EARTHWORK QUALITY CONTROL OVERVIEW

AND AS-BUILT DRAWINGS

CONSTRUCTION OF STAGE I

SHOOTARING CANYON URANIUM PROJECT

## CENTERLINE KEY TRENCH PLAN & PROFILE AND MISCELLANEOUS DETAILS

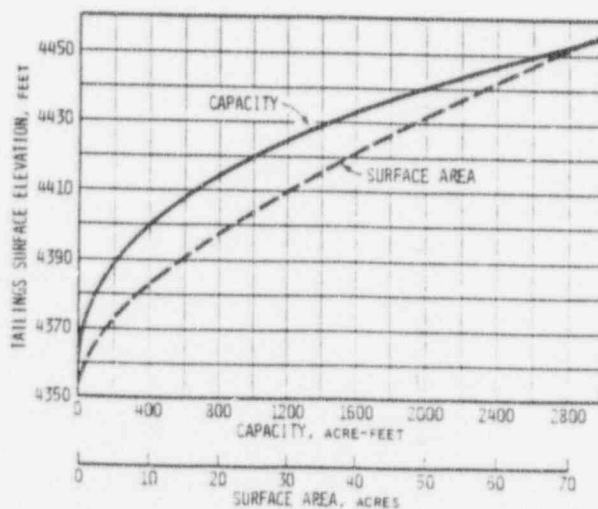
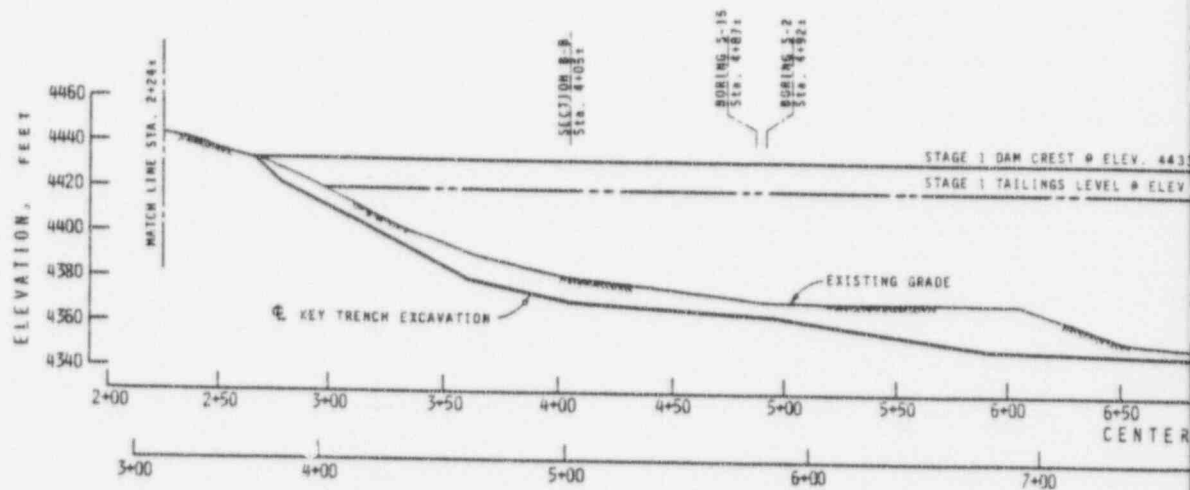
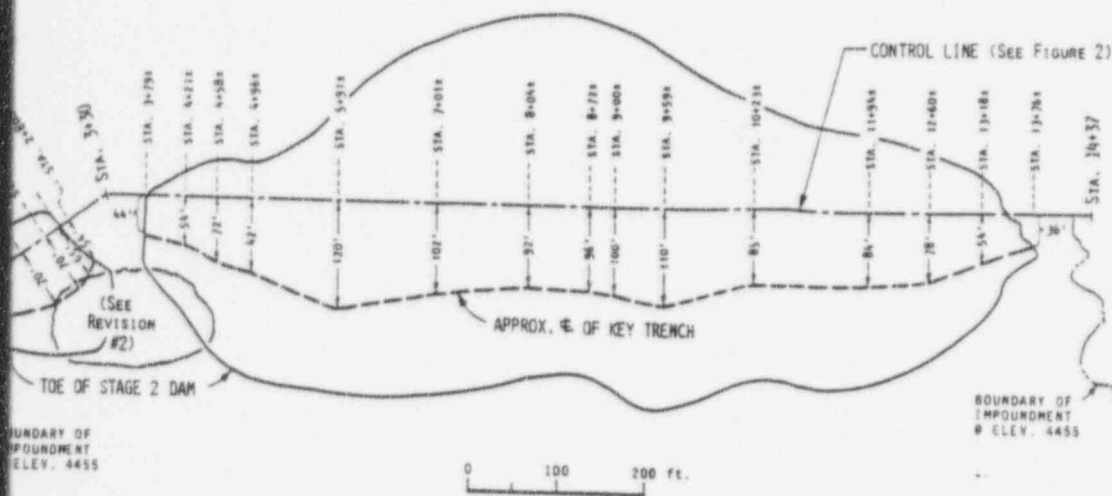
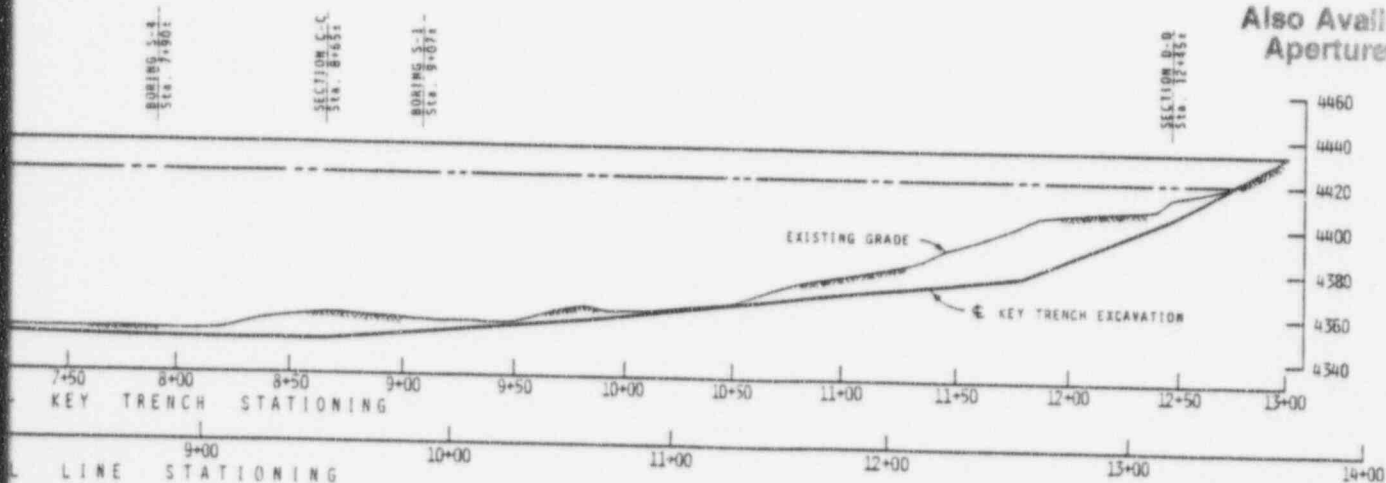
No.	DATE	REVISIONS	BY
2	6-23-82	See Revision #2 on Figure 3	SBG
1	4-8-80	DIRECTED DETAILS A & B: PROVIDED NEW PIPE DETAILS UNDER CELL BERMS & NEW TRENCH BERM	DWG/DAP
APPROVED:			
DATE: 5-24-79

Figure 5

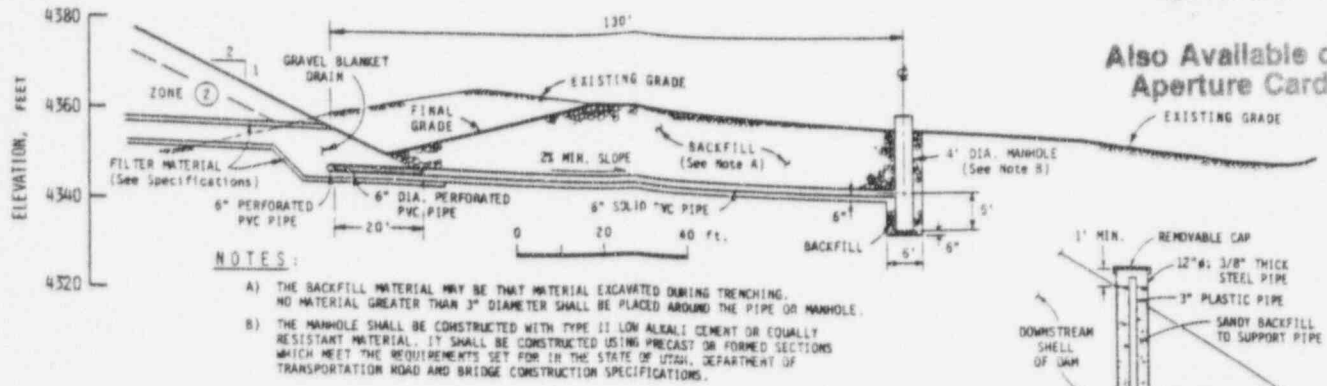
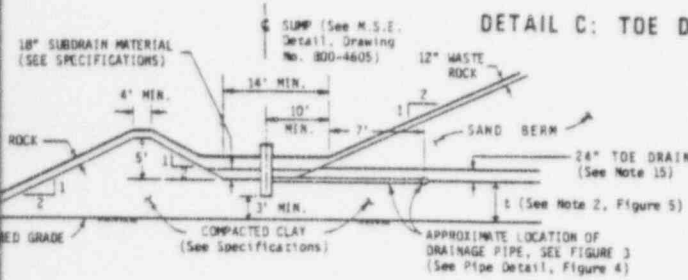
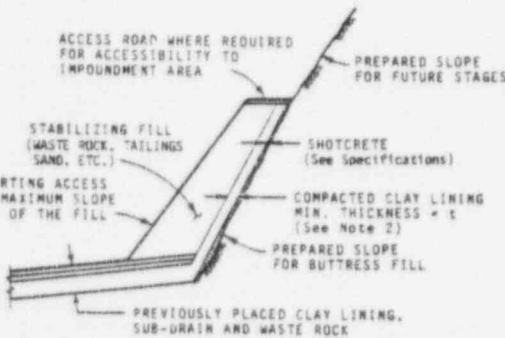
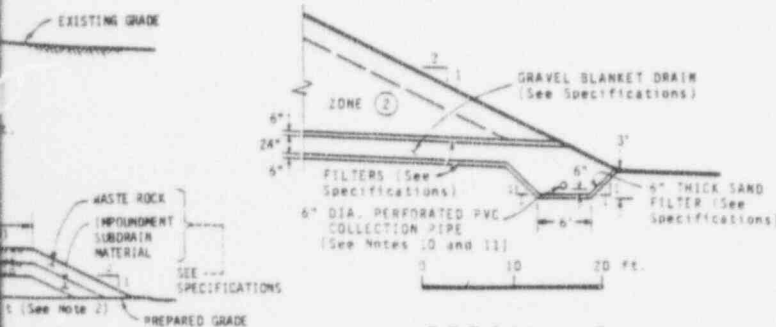
2	6-23-82	AS-BUILT Corrections are shown on HSM Drawing 1-4 or as noted in revision #2 on Figure 3.	DRG
1	4-8-80	CORRECTED DETAIL 3; ADDED NOTE 15, UPRATE 11; WHY THE DETAIL MODIFIED NOTES 2, 3, 11, 12	BBG/DAP
No.	DATE	REVISIONS	By
R.E. NO.	1933	APPROVED:	
DATE	5-24-79	<i>Bernard B. ...</i>
